Well Name: FEASEL A	Well Location: T28N / R10W / SEC 34 / NWNW / 36.622752 / -107.888394	County or Parish/State: SAN JUAN / NM
Well Number: 3R	Type of Well: CONVENTIONAL GAS WELL	Allottee or Tribe Name:
Lease Number: NMSF046563	Unit or CA Name:	Unit or CA Number:
US Well Number: 3004529765	Operator: HILCORP ENERGY COMPANY

Subsequent Report

Type of Submission: Subsequent Report	Type of Action: Plug and Abandonment
Date Sundry Submitted: 05/13/2025	Time Sundry Submitted: 12:11
Date Operation Actually Began: 05/08/2025

From: Kuehling, Monica, EMNRD <monica.kuehling@emnrd.nm.gov>
Sent: Monday, January 13, 2025 2:47 PM
To: Kade, Matthew H; Joe Zimmerman; Rennick, Kenneth G
Cc: Farmington Regulatory Techs; John LaMond; Lee Murphy; Clay Padgett
Subject: RE: [EXTERNAL] P&A Revision Request for Hilcorp's FEASEL A 3R (API: 3004529765)

Current Schematic - Version 3

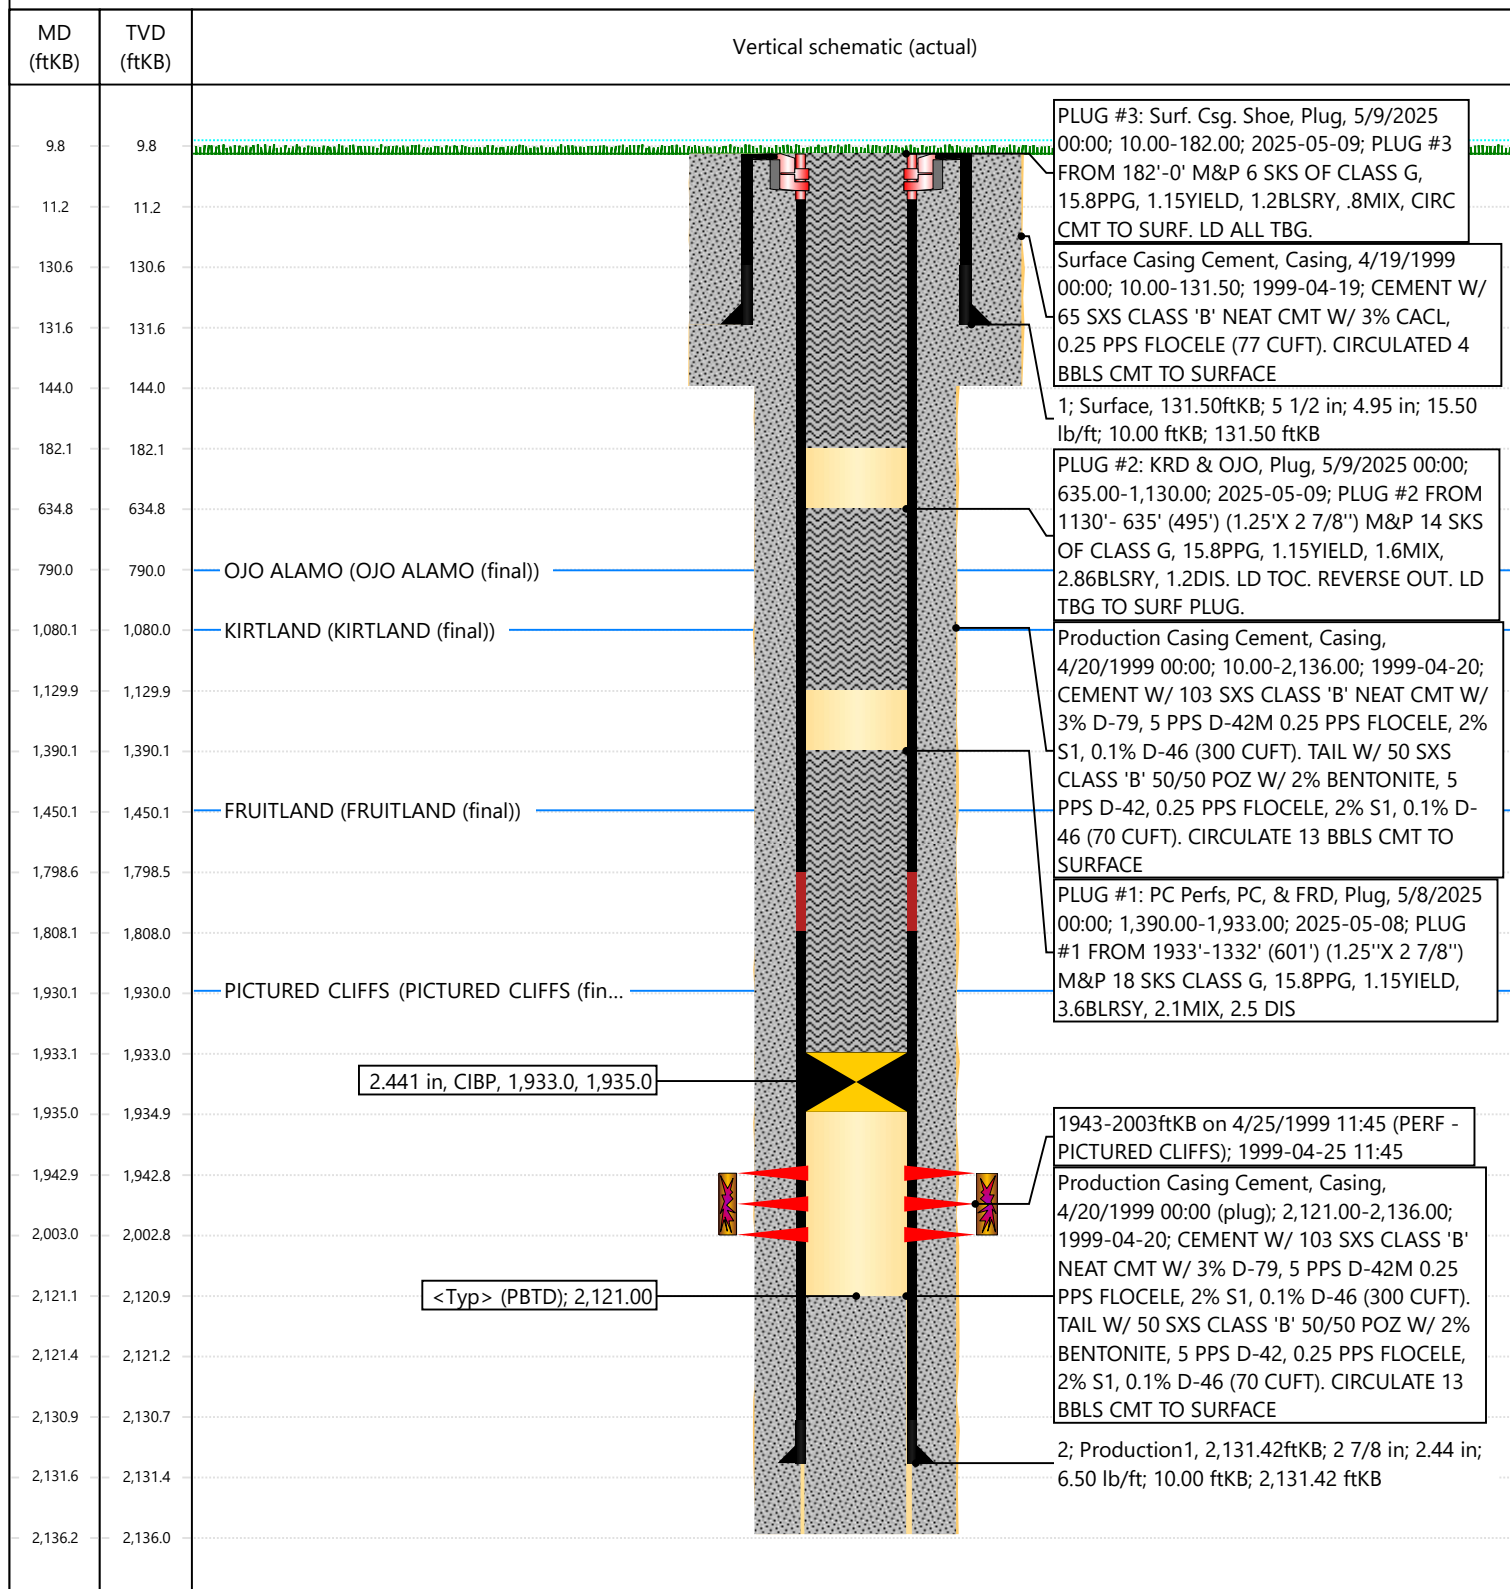
Below are the changes to the procedure, which consist of changes to formation tops and cement plug depths.

- **PLUG #1: 17sx of Class G Cement (15.8 PPG, 1.15 yield); PC Perfs @ 1,943' | PC Top @ 1,930' | FRD Top @ 1,450':.**
Pump a 17 sack balanced cement plug inside the 2-7/8" casing (est. **TOC @ +/- 1,350'** & est. **BOC @ +/- 1,933'**). Wait on Cement for 4 hours, tag TOC w/ work string.

- **Increased top of cement to account for BLM's Fruitland top.**
- **PLUG #2: 13sx of Class G Cement (15.8 PPG, 1.15 yield); KRD Top @ 1,080' | OJO Top @ 790':**
Pump a 13 sack balanced cement plug inside the 2-7/8" casing (est. **TOC @ +/- 690'** & est. **BOC @ +/- 1,130'**). *Note cement plug lengths & volumes account for excess.

- **Increased bottom and top of cement to account for BLM's Kirtland and Ojo Alamo tops.**
- **PLUG #3: 6sx of Class G Cement (15.8 PPG, 1.15 yield); Surf. Casing Shoe @ 132':**
Pump a 6 sack balanced cement plug inside the 2-7/8" casing (est. **TOC @ +/- 0'** & est. **BOC @ +/- 182'**). *Note cement plug lengths & volumes account for excess.

- **Brought bottom of cement higher due to BLM having Nacimiento at surface. Bottom of cement now 50' below surface casing shoe.**

NMOCD approves below

The BLM approves of the updated procedure.
